# **Analog Pre-emphasis and the Tx Template**

**by  
Clark Foley  
Member of Technical Staff  
High Frequency/Fiber Communication  
Maxim Integrated Products**

# Tx Template Modification

# Transmit Pre-Emphasis

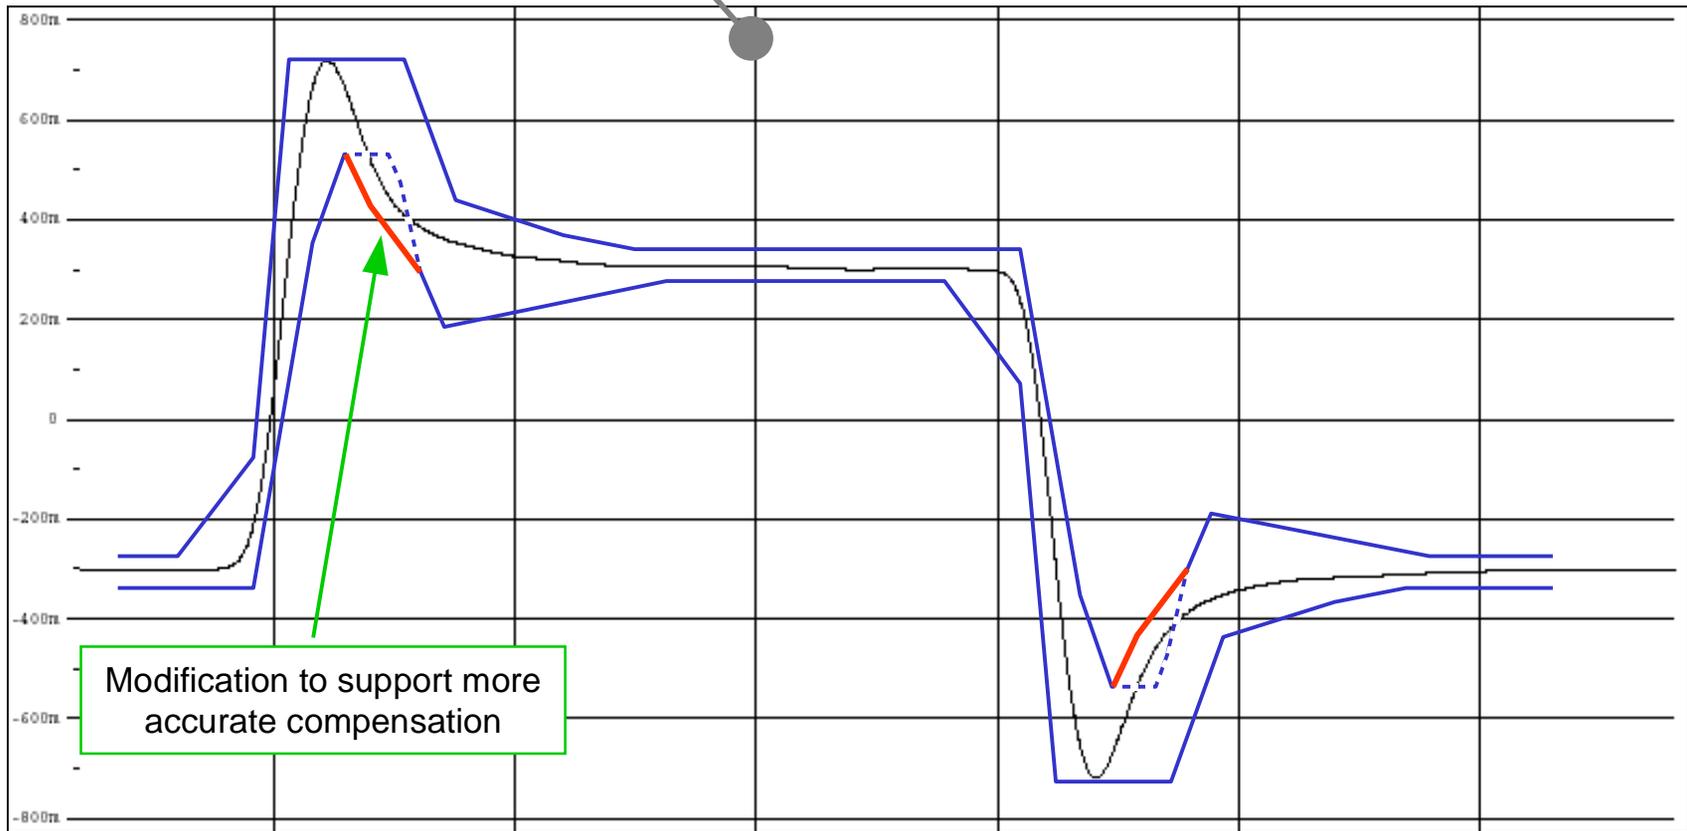
Existing Tx Template is crafted for 1-bit wide pre-emphasis and it is implementation specific.

This excludes more accurate solutions:

Fractional delay/sub-bit timing

Analog filter

## Proposed Modification

time(ps)	Upper	time(ps)	Lower
0	-0.4500	0	-0.5500
131	-0.4500	189	-0.5500
283	-0.1250	287	-0.5500
283	-0.1250	319	-0.2660
291	0.0000	349	0.0000
343	0.8500	414	0.5860
363	1.1750	477	0.8700
451	1.1750	503	0.7700
602	1.1750	530	0.6700
629	1.0600	581	0.5820
669	0.8880	606	0.5380
709	0.7150	631	0.4940
709	0.7150	685	0.3060
931	0.6000	989	0.4000
1091	0.5500	1149	0.4500
1789	0.5500	1731	0.4500
1887	0.5500	1883	0.1250
1919	0.2660	1883	0.1250
1949	0.0000	1891	0.0000
2014	-0.5860	1943	-0.8500
2077	-0.8700	1963	-1.1750
2103	-0.7700	2051	-1.1750
2130	-0.6700	2202	-1.1750
2181	-0.5820	2229	-1.0600
2206	-0.5380	2269	-0.8880
2231	-0.4940	2309	-0.7150
2285	-0.3060	2309	-0.7150
2589	-0.4000	2531	-0.6000
2749	-0.4500	2691	-0.5500
3200	-0.4500	3200	-0.5500
3360	-0.4500	3360	-0.5500

Modify the Tx Template to accommodate analog filters and sub-bit interval/multi-bit FIR.

- Use analog filter as the target transient response for sub-bit interval/multi-bit FIR
- 1-bit FIR will still fit the template
